Item ID: D407-667-105 Accept ***N900040100*** Setup Start ***NS1***
 Revision ID: Stop ***NS2***
 Item Name: Fwd Crosstube - High 407
 Start Date: 6/17/2015 Start Qty: 1.00 ***1*** Cust Item ID:
 Required Date: 6/26/2015 Req'd Qty: 1.00 ***1*** Customer:
 Reference:

DRAWING NO. D407-667-145	TITLE CROSSTUBE ASS'Y (407 HIGH FWD)	REV. C	DART AEROSPACE LTD ENGINEERING ORDER		D.E.O. NO. D407-667-145-C-1	SHEET NO. SHEET 1 OF 1	SCALE NTS
DRAWN <i>Q</i>	CHECKED <i>ASS</i>	MFG. APPR. <i>IB</i>	APPROVED <i>MD</i>		DE APPR. <i>HA</i>		
DATE 11.07.15	DATE 11.07.22	DATE 11.07.22	DATE 11/07/22		DATE 11.07.21

DART AEROSPACE LTD		Work Order:	133763
Description: Crosstube High Fwd (407)		Part Number:	D407-667-105
Inspection Dwg: D407-667-145 Rev: C		Page 1 of 1

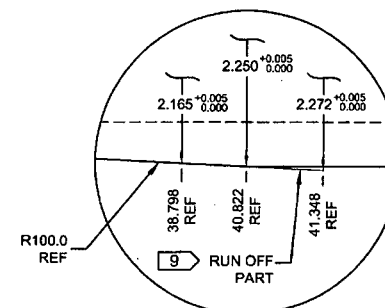
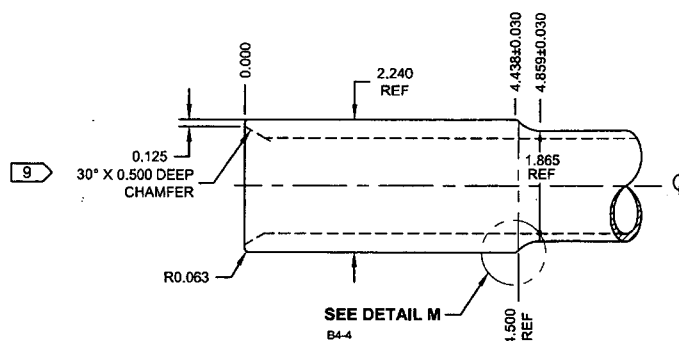
C	REVISE GENERAL NOTES/PART LIST (ZN D7-1); REORGANIZED VIEWS AND REFORMATTED DRAWING TO CURRENT STANDARDS. D3595-063-395 WAS D2856-400-694 (ZN D6-2 & A5-2); REMOVED REF. 7 ADD TOLERANCES (ZN C6-3, C4-3, D2-3); RELOCATED FLAG #6 (ZN A8-3) PER NCR 210; MOVED TURNING DETAIL & UPDATED TOLERANCE TO SHEET 4.	RF	08.11.06
B	ADD HOLES AND NUT PLATES FOR COMPATABILITY WITH BHT/AA SKUDTUBES	PH	05.07.26
A	NEW ISSUE	CP	02.05.08
REV.	DESCRIPTION	BY	DATE
DESIGN	RF	DART AEROSPACE LTD HAWKESBURY, ONTARIO, CANADA	
DRAWN	RF	DRAWING NO.	REV. C
CHECKED	RF	D407-667-145	SHEET 1 OF 4
MFG. APPR.	RF	TITLE	SCALE
APPROVED	RF	CROSSTUBE ASS'Y (407 HIGH FWD)	NTS
DE APPR.	RF	COPYRIGHT © 2002 BY DART AEROSPACE LTD THIS DOCUMENT IS PRIVATE AND CONFIDENTIAL AND IS SUPPLIED ON THE EXPRESS CONDITION THAT IT IS NOT TO BE USED FOR ANY PURPOSES OR COPIED OR COMMUNICATED TO ANY OTHER PERSON WITHOUT WRITTEN PERMISSION FROM DART AEROSPACE LTD

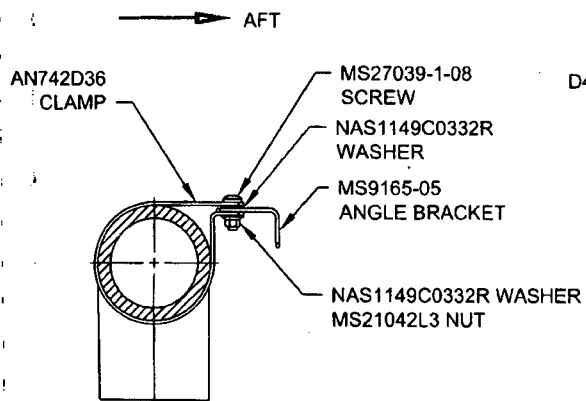
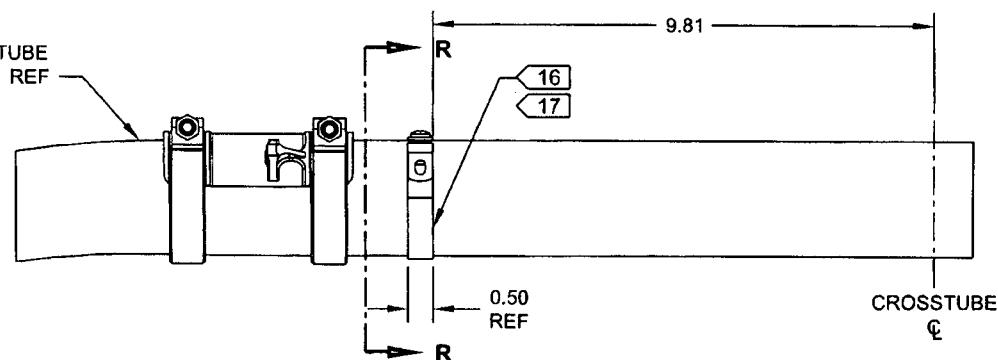
PURPOSE:

ADD ELECTRICAL GROUNDING STRAP

ITEM	QTY -145	PART NUMBER	DESCRIPTION
1	X	D407-667-145	CROSSTUBE ASSEMBLY (407 HIGH FWD)
10	2	AN742D36	CLAMP
11	2	MS9165-05	ANGLE BRACKET
12	2	MS21042L3	NUT (OR MS21042-3)
13	2	MS27039-1-08	SCREW
14	4	NAS1149C0332R	WASHER (OR AN960C10L)

- 16) MASK AREA UNDER CLAMP PRIOR TO PAINTING
- 17) SEAL EDGES WHERE AN742D36 CLAMP MEETS WITH THE CROSSTUBE USING SIKAFLEX-241/-291 OR MIL-S-8802 CLASS B2 OR PROSEAL 890 SEALANT
- 18) PERFORM RESISTANCE CHECK TO ENSURE MAX RESISTANCE IS 10 MILLIOHMS
